SAFETY EVALUATION BY THE OFFICE OF NUCLEAR REACTOR REGULATION

SUPPORTING AMENDMENT NO. 46 TO FACILITY OPERATING LICENSE NO. NPF-1

TROJAN NUCLEAR PLANT

DOCKET NO. 50-344

Figure 1 Interpretation of DNB Ratio Safety Limit With The Improved Thermal Design Procedure

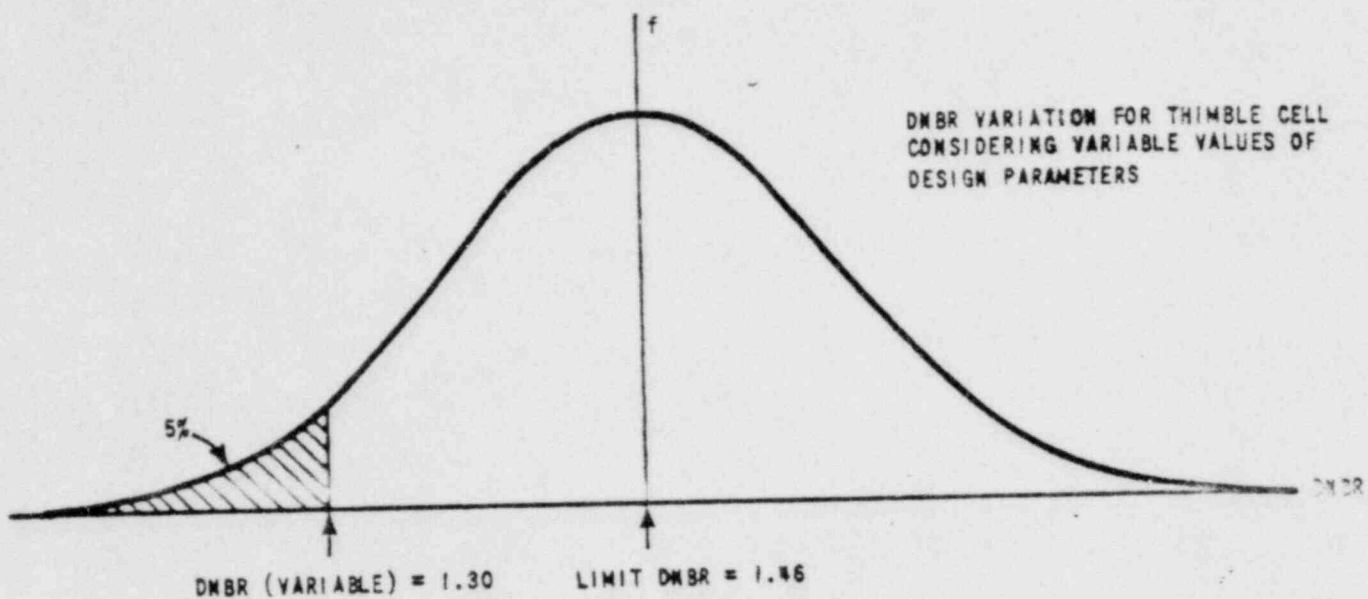
The significance of the change in the safety limit criterion is shown in Figure 1 (taken from Reference 3). While the fixed value method used the 1.30 value (with the W-3 correlation) as a limit, the Improved Thermal Design Procedure allows this limit to be exceeded with a 5% probability. The difference is subtle but significant. While the fixed value method establishes a safety limit which gives a 95% probability the DNB will not occur with a 95% confidence, the limit of the Improved Thermal Design Procedure gives a 95% probability that the safety limit of the fixed value method will not be exceeded with a 95% confidence. The limit of the Improved Thermal Design Procedure is called the design limit.
